Access Compliance Report

Public Rights-of-Way

(Curb Ramps)

Intersection ID: 48133	Main Street: WHISTLER'S CHASE DR	Cross Street: ACORN CREEK LN	Location: NE
ADA ID: 1FC80DB05099	Ramp Type: BlendTrans1	Initial Pass/Fail: Pass	Overall Compliance: No
Severity Score: 7.5			
Codes/Mitigation Info/Possible Solution		Field Measurements/Component Compliance

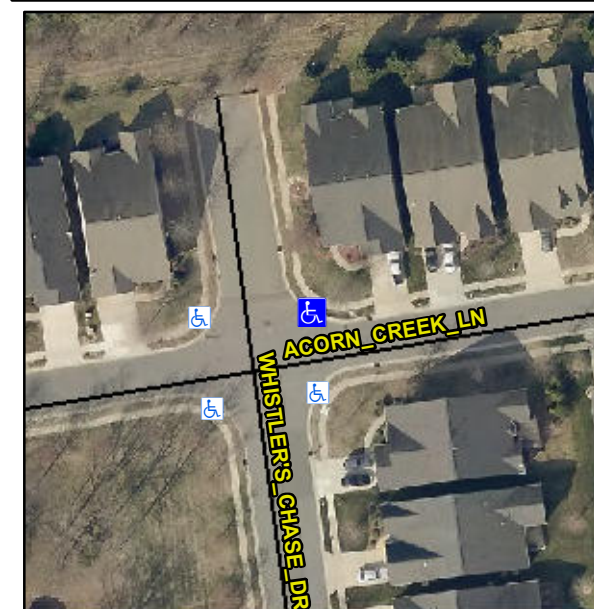
Not Found, R304.2.1, R304.2.2-Perp, R304.3.2-Para, R305.2, R302.7.2

Compliance	Description	Data	Compliance	Description	Data
N/A	Ramp Length (in)	46.0	Yes	BlendTrans Slope (%)	4.0
Yes	Ramp Width (in)	48.0	Yes	BlendTrans XSlope (%)	1.2
N/A	Flare Type LT	Sloped	N/A	Flare Type RT	Sloped
N/A	Flare Slope LT (%)	2.2	N/A	Flare Slope RT (%)	1.1
N/A	Flare Traversable LT?	No	N/A	Flare Traversable RT?	No
No	Landing Length (in)	47.5	Yes	DWS Provided?	Yes
Yes	Landing Width (in)	54.0	Yes	DWS Contrast?	Yes
No	Landing Slope (%)	2.3	Yes	DWS Length (in)	24.0
Yes	Landing X Slope (%)	0.3	Yes	DWS Full Width?	Yes
N/A	Landing Curb? (Y/N)	No	No	DWS Offset (in)	3.0
N/A	Shared Landing?	No			
Yes	Gutter Ponding?	No	Yes	Gutter Slope (%)	3.2
No	Gutter Lip Ht (in)	0.5	Yes	Gutter X Slope (%)	0.1
N/A	Painted X Walk1?	No	N/A	Painted X Walk2?	No
	X Walk 1 Direction	To SW		X Walk 2 Direction	To S
	X Walk 1 Width (in)	N/A		X Walk 2 Width (in)	N/A
	X Walk 1 Slope (%)	3.3		X Walk 2 Slope (%)	1.7
	X Walk 1 X Slope (%)	3.1		X Walk 2 X Slope (%)	2.2

N/A	Ramp inside XWalk1?	N/A	N/A	Ramp inside XWalk2?	N/A
	Road Slope (%)	2.3		Clear Space?	Yes
	Road X Slope (%)	4.2	N/A	Clear Space to XWalk (in)	N/A
Yes	Any Obstructions?	No	Yes	Storm Grate/Utility Hazard?	No
	Obstruction Type			Storm Grate/Utility Type	
		N/A			N/A
			Yes	Surface Condition? (G/P)	Good
			No	Curb Slope (%)	11.5

Remove & Replace Curb Ramp With Two New Directional Ramps or Equivalent.
